COUNCIL ASSESSMENT REPORT SYDNEY SOUTH PLANNING PANEL

PANEL REFERENCE & DA NUMBER	PPSSSH-159 – DA No. 30-2024
PROPOSAL	Demolition of existing buildings and construction of a five-storey mixed use development comprising of a 'Registered Club and 'Community Facility', 'commercial premises', 'function centres' 'food and drink premises' and 'business identification signage' with two levels of basement parking and associated landscaping.
ADDRESS	206-214 Lakemba Street, Lakemba Lot 1 DP 601048 Lot B DP 359878 Lot B DP 356540 Lot 2 DP 16610 Lot A DP 369191 Lot B DP 369191 Lot 1 DP 9727
APPLICANT	The Greek Orthodox Community of New South Wales
OWNER	The Greek Orthodox Community of New South Wales
DA LODGEMENT DATE	2 February 2024
APPLICATION TYPE	Development Application
REGIONALLY SIGNIFICANT CRITERIA	Section 2.19(1) and Clause 5 of Schedule 6 of State Environmental Planning Policy (Planning Systems) 2021 declares the proposal regionally significant development as: The Development is for a Community Facility and has a capital investment value of more than \$5 million.

PREVIOUS BRIEFINGS	<ul style="list-style-type: none"> • Preliminary Briefing: 11 March 2024 • Follow up Briefing: 14 June

Figure 3: Proposed Height Breach
Source: Katris Architects

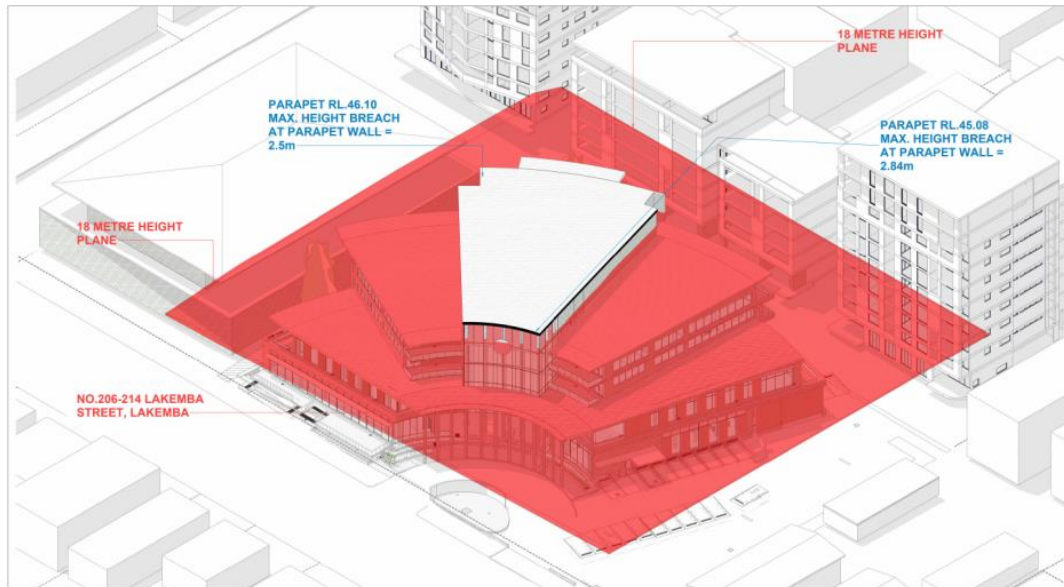
However, as noted within the table above, Council is unable to confirm the extent of the height breach based on the information submitted. The most recent set of architectural plans submitted comprise a lift overrun which consists of an RL of 45.92. There is concern that given the slope of the site, the extent of the proposed height breach could be the greatest at this point and hasn't been considered by the Applicant.

- The proposed reception lounge which forms the proposed height breach can be incorporated within the design and comply with the maximum building height development standard pursuant to the height of building definition contained within CBLEP 2023. The definition does not provide concessions for community spaces to breach such controls.

- Although the site is flood affected, the additional height required above the existing natural ground level, as outlined within Council's Stormwater Systems Report (SSR) is negligible and doesn't reflect the extent of the height breach proposed. The SSR requires habitable floor to be 25m AHD. It is noted that the flood impact assessment report prepared by the Applicant notes that the habitable floor level is to be 25.2 AHD. However, Council's Assets Planner has requested that the report provide evidence that the flood modelling undertaken has been validated against Council's flood levels provided in the SSR. Notwithstanding this, the proposal comprises a habitable ground floor level of 25.35m (which is greater than both suggested levels). Where the proposed

- Based on the solar access information submitted, Council is not satisfied that the proposal (specifically the proposed height breach) does not result in further adverse overshadowing impacts on adjoining residential properties. The solar access and overshadowing plans submitted are inconsistent and therefore cannot be relied upon for assessment. Furthermore, the plans do not indicate the additional shadow cast by the proposed height breach (despite being asked by Council to provide), and therefore the overshadowing impact associated with the proposed height breach is unknown.
- The proposal is deficient in parking to cater for the proposed use and therefore the additional height sought (which incorporates additional gross floor area) does result in adverse environmental impacts from a parking and traffic perspective.
